**URGENT**  
**DEPARTMENT OF THE ARMY TECHNICAL BULLETIN**

**INSTRUCTIONS FOR UPGRADE OF  
ROTOR TRACK AND BALANCE ACCESSORY KIT  
AH-64A KITS/SETS**

**Headquarters, Department of the Army, Washington, D.C.  
15 March 2004**

**TB 1-1520-238-20-137**

**Figure 1**

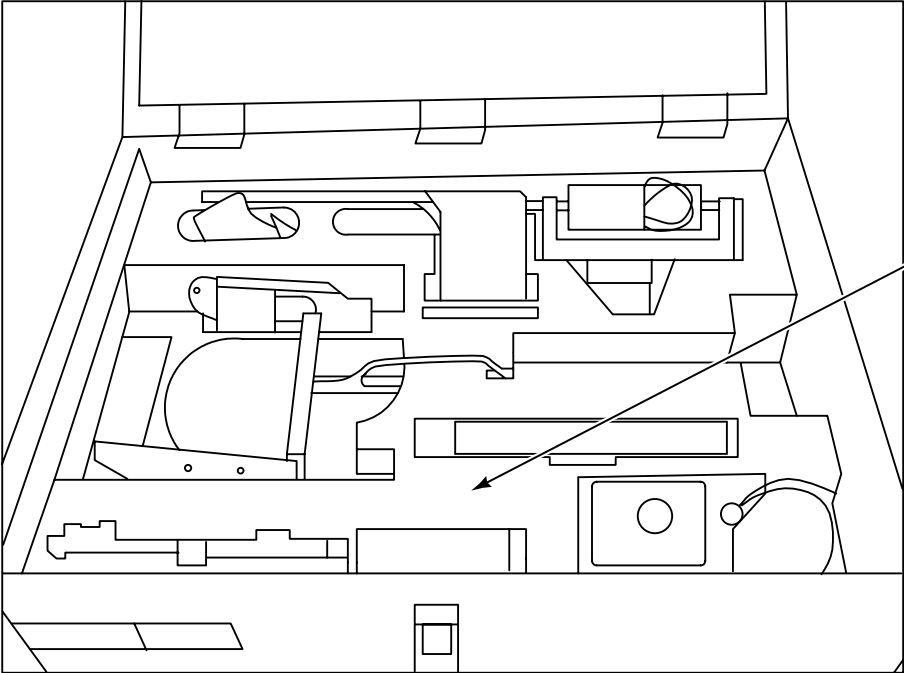
- 1.2** For units with the 7-26210008-613 Rotor Track and Balance Accessory Kit with the 7-262110073-605 wooden Storage and Handling Container, cut a cavity 1" L X 1" W X 1" Deep at the approximate area shown in Figure 1 for the APU Clutch Accelerometer AVA Bracket.

CUT A CAVITY 1" L X 1" W X 1" DEEP FOR THE BRACKET, ACCEL, APU CLUTCH

**Figure 2**

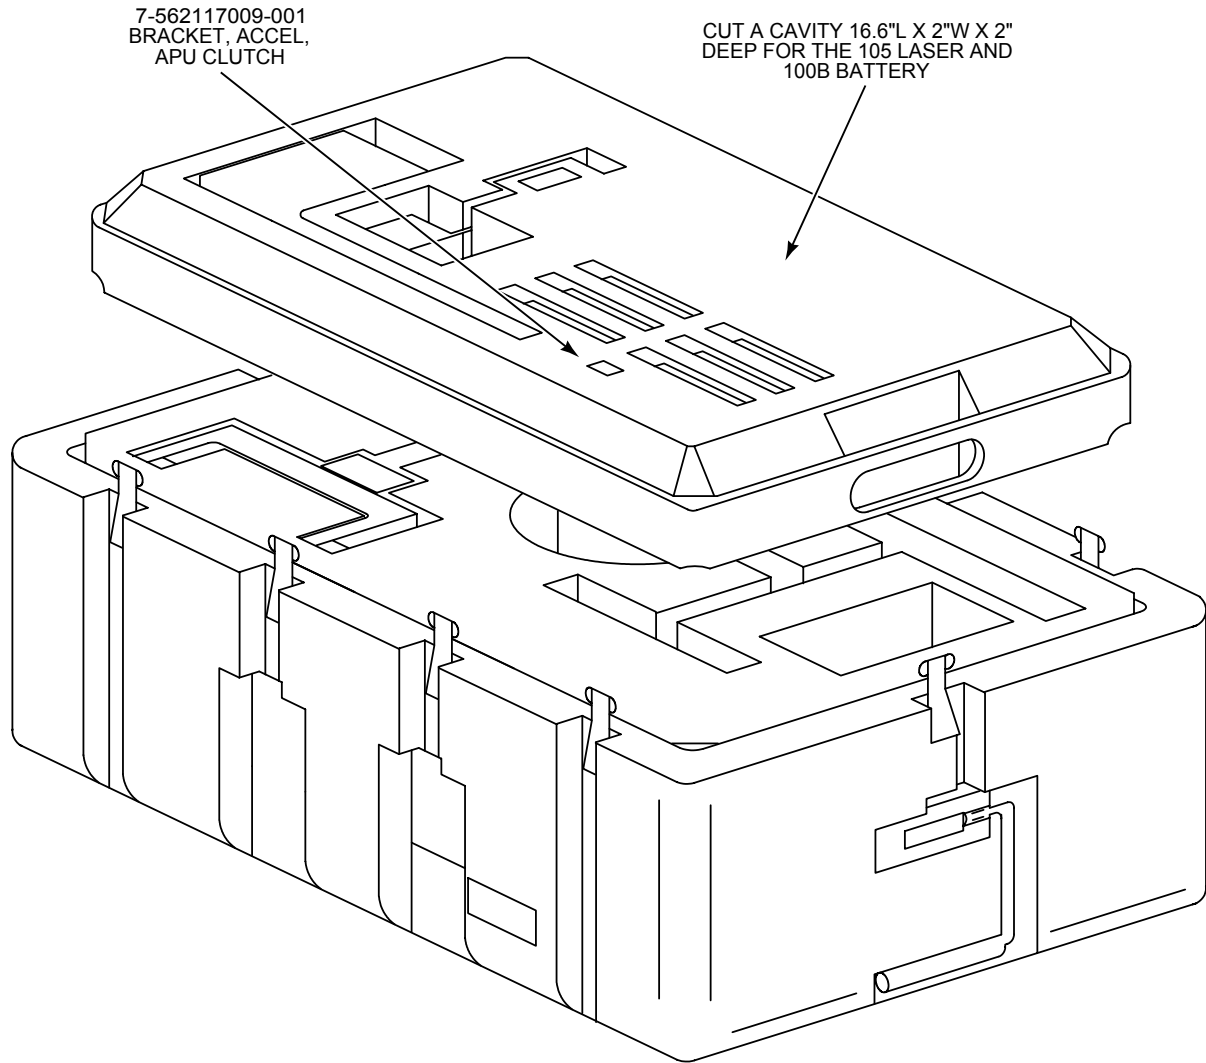
- 1.3** For units with the 7-26210008-615 Rotor Track and Balance Accessory Kit with the 7-562110073-603 roto-molded polyethylene Storage and Handling Container, cut a cavity 2" L X 2" W X 12" Deep at the approximate area shown in Figure 2 for the 105R Laser. Container has a provision the LAS Laser and 7-562110225-601 Laser Adapter.
